MFN 06-135
Supplement 1

Subject: **Response to Portion of RAI Letter Number 20 Related to ESBWR Design Certification Application – Seismic Design – RAI Numbers 3.7-2, 3.7-13, 3.7-17, 3.7-18, 3.7-19, 3.7-21, 3.7-22, 3.7-36, 3.7-40, 3.7-47, 3.7-48, 3.7-49, 3.7-51, and 3.7-53 – SUPPLEMENT 1**

MFN 06-135, SUPPLEMENT 1

Response to Portion of RAI Letter Number 20

Figure 3.7-48 (1) Passive Soil pressure for Energy Components of Embedment

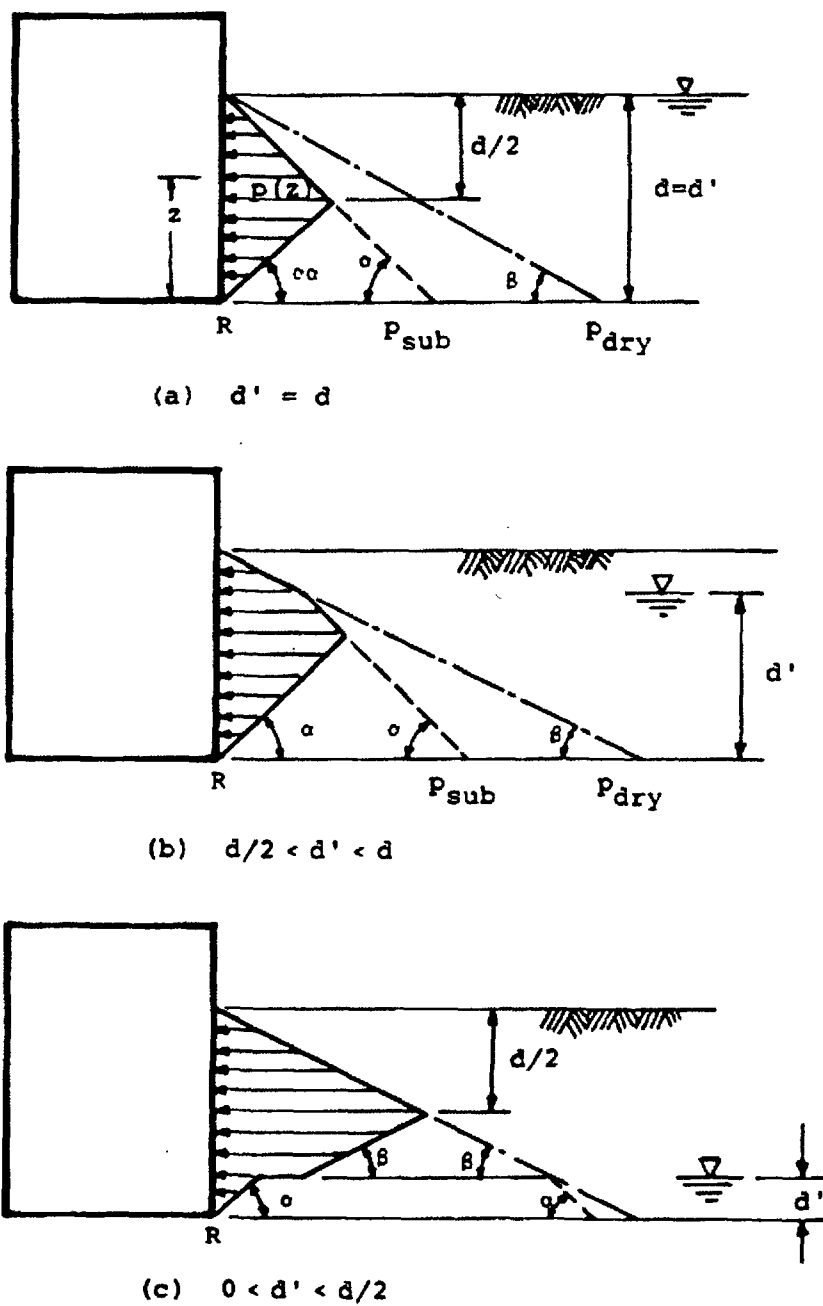
In DCD Section 3.7.2.14, the applicant described the use of an energy method to evaluate the stability of structures against seismically induced overturning moments. The applicant is requested to provide a more detailed description of the analysis method, including an explanation of how the energy components for the embedment (W_p) and buoyancy (W_b) are determined, and the technical justification for the two equations given for the velocity terms (V_h and V_v).

Energy components for the embedment (W_p) is illustrated in Figure 3.7-48 (1).

For the structure to reach the overturning position, the additional work required to be done against the side soil is, according to Figure 3.7-48 (1) (a):

Figure 3.7-48 (2) Energy Components for Buoyancy

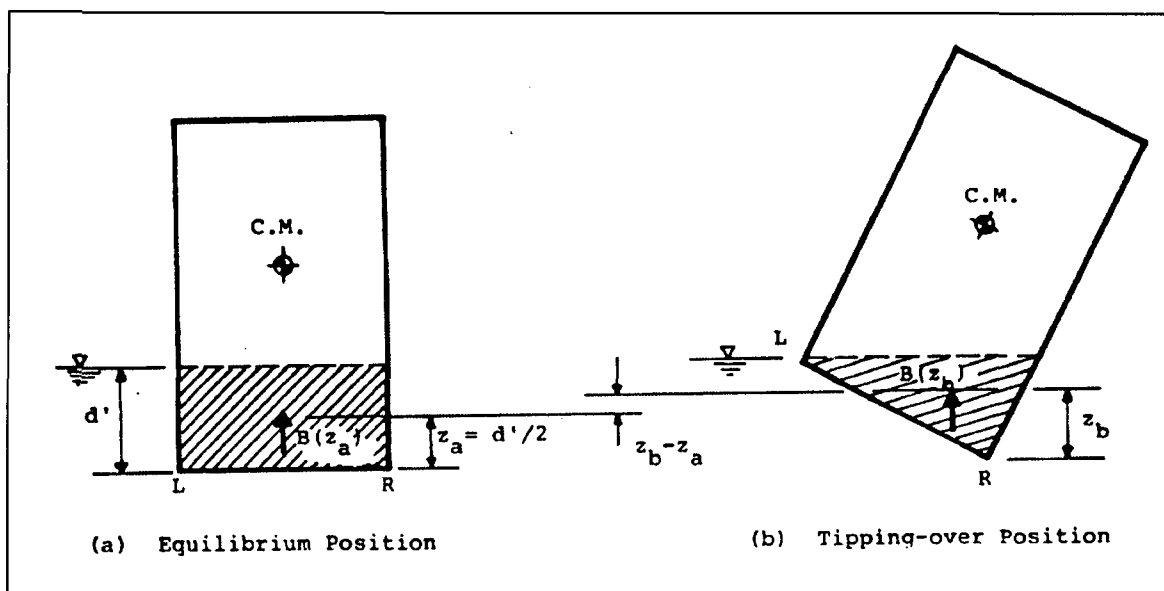
1. *Provide the corrected Equation 4-17 found in BC-TOP-4-A, Rev.3, Seismic Analyses of Structures and Equipment for Nuclear Power Plants, November 1974, Bechtel Power Corporation.*
2. *Provide the technical basis for using the SRSS method to combine the contribution from peak values of ground velocity and relative velocity.*

Energy components for the buoyancy (W_b) is illustrated in Figure 3.7-48 (2).

in which, according to Figure 3.7-48 (2), z_a and z_b are the height of the centroid of buoyant force above the edge R for the equilibrium position (a) and the tipping over position (b) respectively. Note that is equal to $d'/2$. For practical purposes, Eq. (6) is approximated by:

1. GE found from its independent derivation that there is an error in Equation 4-17 in the above document. It should be corrected as follows:

(Corrected Equation)
$$W_b = (z_b - z_a)[B(z_b) - B(z_a)]/2 + B(z_a)(z_b - z_a)$$

Figure 3.7-49 (1) Approximate Method of Soil Spring

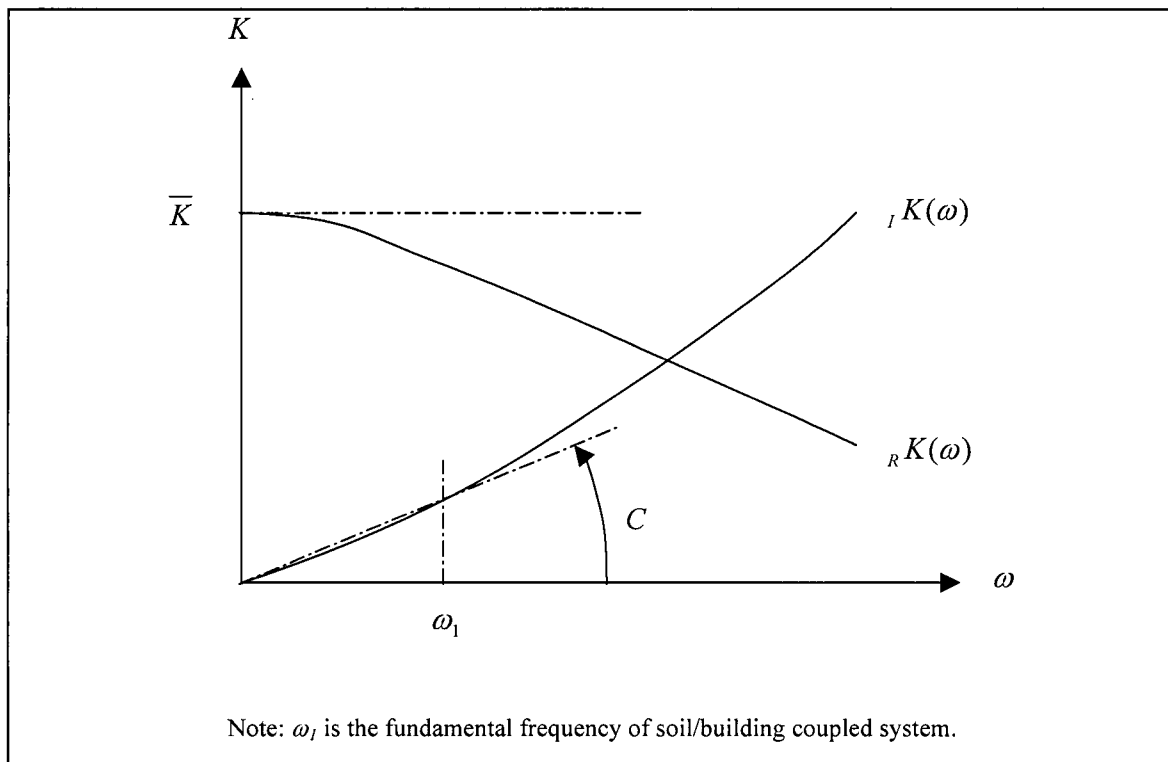
- 1. Detailed finite element (FE) RB/FB model (including figures showing mesh plots, node numbering, etc.) used for the development of the lumped-mass stick model.*
- 2. Detailed fixed-base (fixed at the top of the foundation mat) lumped-mass stick model used in GE's SSI analyses.*
- 3. Large-size structural design drawings of the RB/FB. Specifically, drawings showing the detailed foundation mat and embedded side walls are needed.*
- 4. Soil information used to develop soil springs and soil damping for the SSI analyses of the RB/FB supported by the soft soil condition.*
- 5. Description of the computer code "DAC3N" used by GE for the SSI analyses.*
- 6. Input ground motion time history text files in digitized form.*
- 7. Description of the SSI analytical formulation and digitized response computation results.*

As shown in Figure 3.7-49(1), the base spring value derived from the vibration admittance theory is a function of frequency ω , and can be represented by complex stiffness ${}_R K(\omega) + i {}_I K(\omega)$ (where ${}_R K$ is the real number portion, and ${}_I K$ is the imaginary portion). However, since the expression $({}_R K(\omega) + i {}_I K(\omega))$ is complicated to be used directly in response analysis, the spring values are simplified and replaced with frequency independent soil spring and damping coefficient, respectively, for the time history analysis solved in time domain. The approximate method is described below.

Figure 3.7-49S1 (1) Method for Frequency-Independent Soil Properties

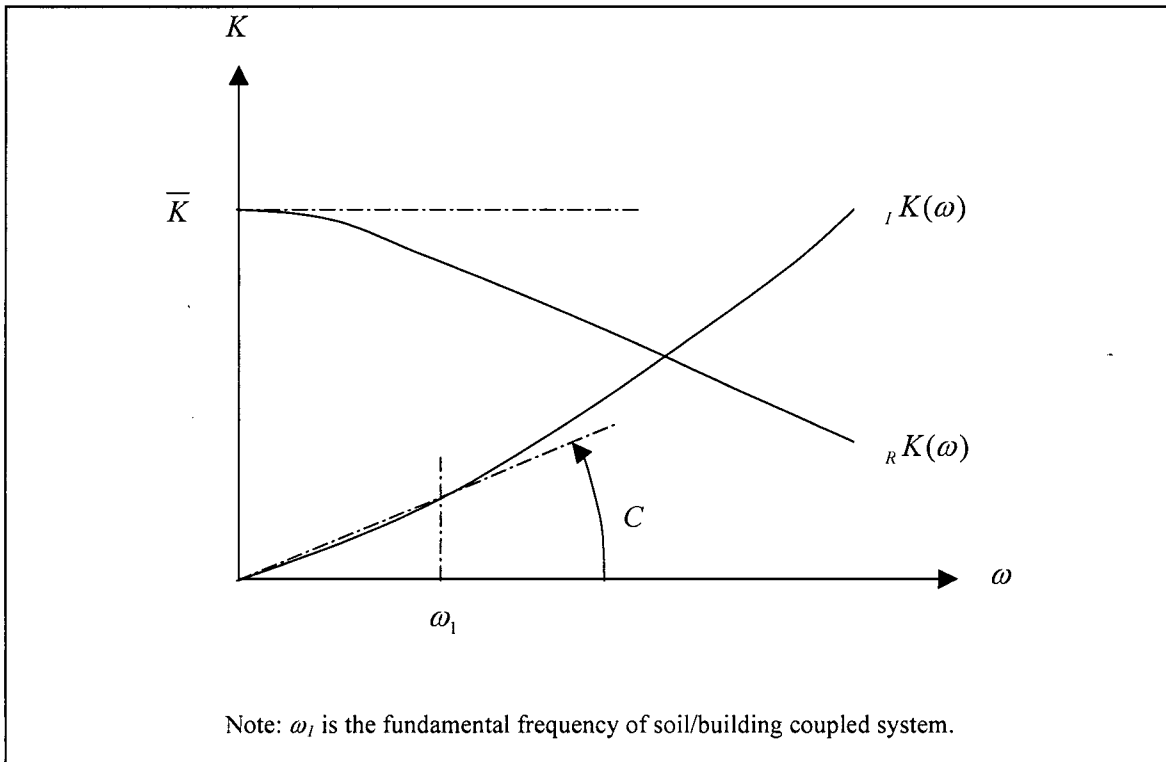
Response was acceptable; however, GE provides clarification of the response as shown below.

As shown in Figure 3.7-49S1 (1), the base spring value derived from the vibration admittance theory is a function of frequency ω , and can be represented by complex stiffness ${}_RK(\omega) + i{}_IK(\omega)$ (where ${}_RK$ is the real number portion, and ${}_IK$ is the imaginary portion). However, since the expression $({}_RK(\omega) + i{}_IK(\omega))$ is complicated to be used directly in response analysis, the spring values are simplified and replaced with frequency independent soil spring and damping coefficient, respectively, for the time history analysis solved in time domain. The method used to obtain the equivalent frequency independent soil stiffness and damping is described below:

Figure 3A.7-4. ESBWR RBFB Complex Seismic Model

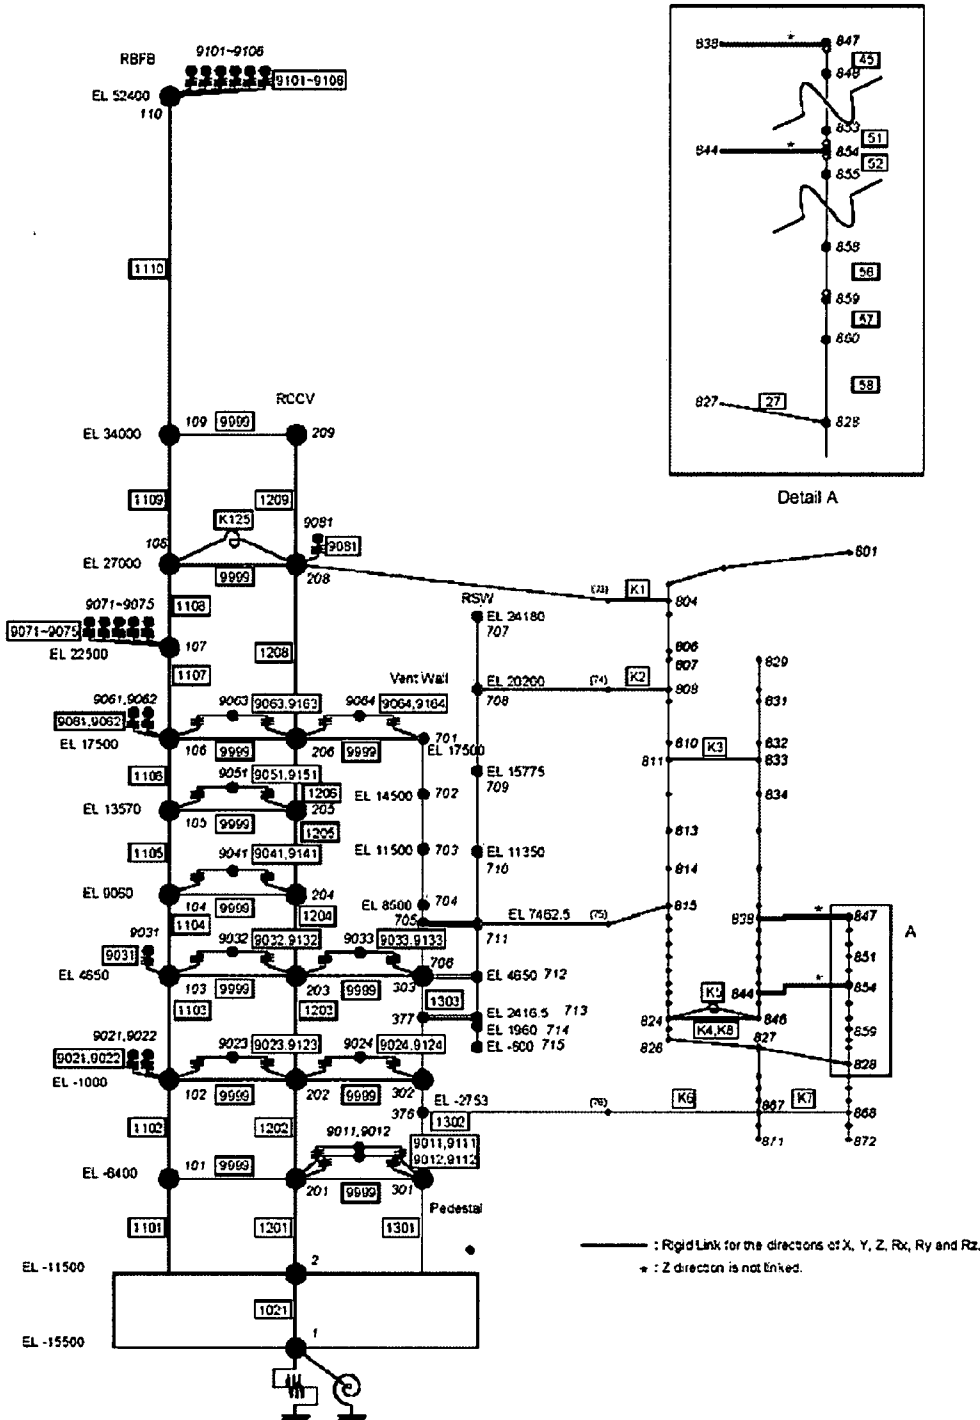
DCD Figure 3A.7-4 does not show eccentricities of individual sticks.

DCD Tier 2 Figure 3A.7-4 will be revised to refer to DCD Tier 2 Figures 3A.7-1 through 3A.7-3 for eccentricities in the next update as noted in the attached markup.

Note: Refer to Figures 3A.7-1 through 3A.7-3 for eccentricities of individual sticks.
